Subject: Beveridge North West PSP

Thank you for the opportunity to review the Beveridge North-West PSP and provide some feedback on the proposed servicing for this area.

Plan 3

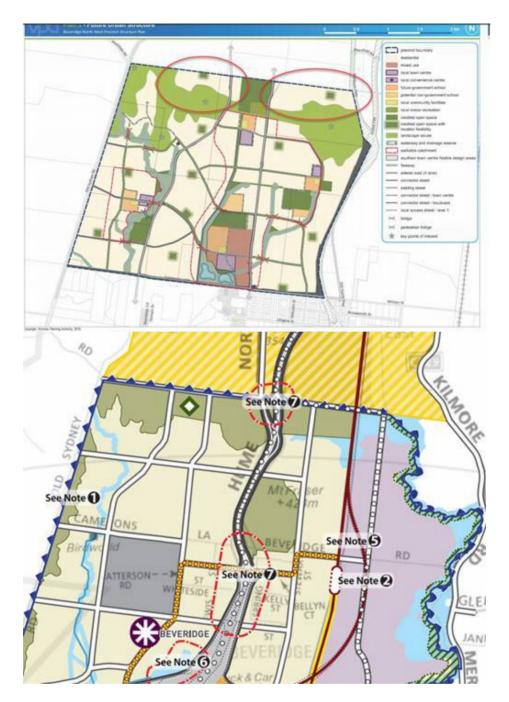
There are additional residential catchments in the northern parts of the PSP that had not been allowed for in our servicing strategy (as they were not identified in the overall published growth area plan). We believe these can be serviced by the planned Rowes Lane branch sewer in the Wallan South PSP (subject to hydraulic modelling confirmation).
